Docket Item #6  
BAR CASE # 2011-0179

**ISSUE:** Alterations (Window and Door Replacement)

**LOCATION:** 516 North Columbus Street

**BAR CASE #2011-0179**

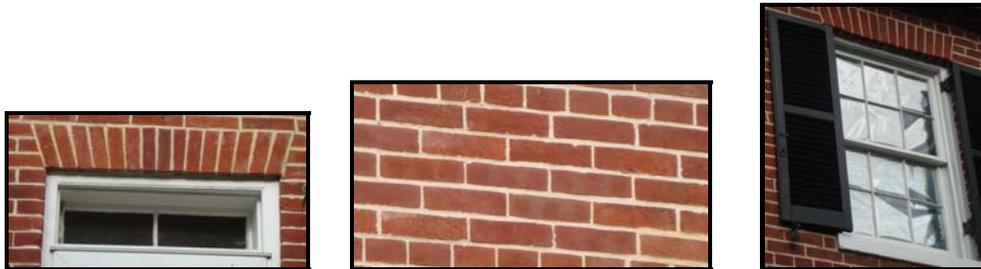
Since the existing windows and doors have been removed and disposed, the BAR is left only with historic documentation and architectural clues to provide information on what materials would have been original to the building. Sanborn Insurance maps illustrate that the eight townhouses in this row (506-520) were all constructed during the same time. Additionally, a site visit has revealed that these townhouses were built as four mirror image pairs (see image below.)

An examination of these buildings revealed that the original front elevation features were likely 6/6, 5/8" muntin, single-glazed wood windows with operable shutters, six-panel wood doors, two--light transoms, brick jack arches, and denticulated brick cornices (as shown below). These vernacular Colonial Revival features are atypical for the late Victorian-era but, as Staff and the BAR are discovering, groups of these remarkably accurate Federal Revival style buildings were constructed in the late 19<sup>th</sup> or early 20<sup>th</sup> century in several pockets throughout Old Town with both 2/2 and 6/6 windows.
